**Comments on the DGEIS / Amended GPP  
from Individuals**

Lower Manhattan Development Corporation  
Attention: Comments WTC Memorial and Redevelopment Plan/DGEIS  
One Liberty Plaza, 20th Floor  
New York, NY 10006

Re: World Trade Center Draft Generic Environmental Impact Statement

World Trade Center Open Spaces  
 Pre-September 11  
 Figure 6-5

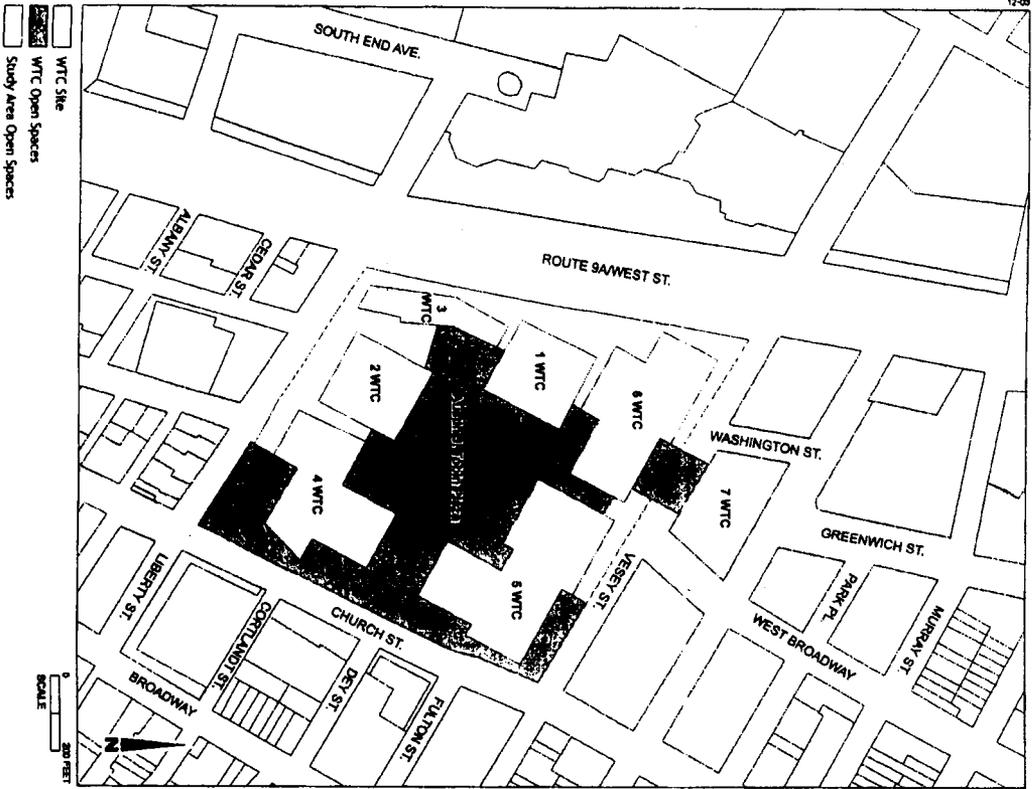
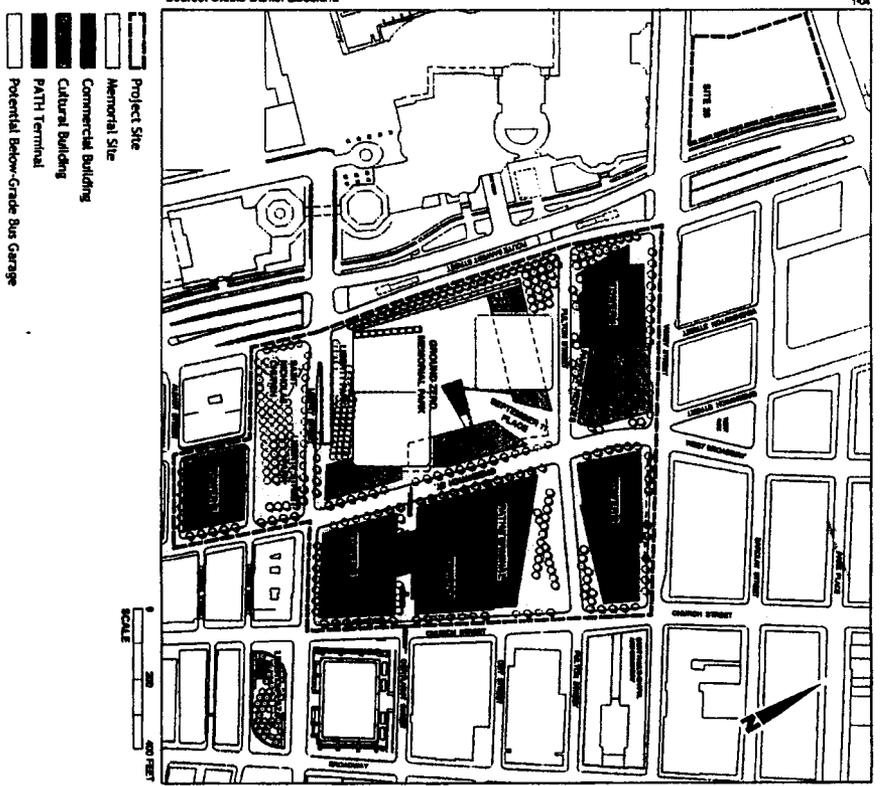
On this board you will see two plans provided by LMDC. One is the original World Trade Center showing the Tobin Plaza and open space. The other is the proposed site plan showing new buildings, the memorial and the proposed open space. Let's look at what passes for Open Space... Examining the original World Trade Center Plan you will notice that the side along 9A West Street did not count as open space until after 9/11. But the legend shows us that, now the road shoulder on the other side of 9A is included in the LMDC open space calculations. I bring this up only to indicate the acres of “open space” can include such unsavory parcels. Essentially, this quality of Open Space is as hospitable as the traffic triangle in Harold Square. Yes, there is a tree and a statue to admire and you could have a cup of coffee or meet a friend there. But would you want to?

With only 5.2 acres of low quality open space to serve that population, LMDC is obliged to include Memorial Space to make up the difference. Adding the Memorial into open space calculations is not only inappropriate and wrong; it acts to obscure how far out of compliance with the CEQR standard the LMDC's proposed plan is.

Interestingly, while reviewing the WTC/EIS for quality of life indicators, I double checked the math on the Open Space figures as set forth on page S-28, Table 2-1 and Table 6-1. The consistent figures are 5.52 acres for open space and 4.2 acres for memorial areas. Simply converting square feet into portions of an acre -Tables 2.1 and 6-1- show the 5.52 acres open space figure converts to 4.85 acres or a 13% overstatement.

However, neither the Actual 4.85 figure nor the exaggerated 5.2 acres restore the net loss of residential amenities -- open space in the pre-911 scenario was 8.13 acres.
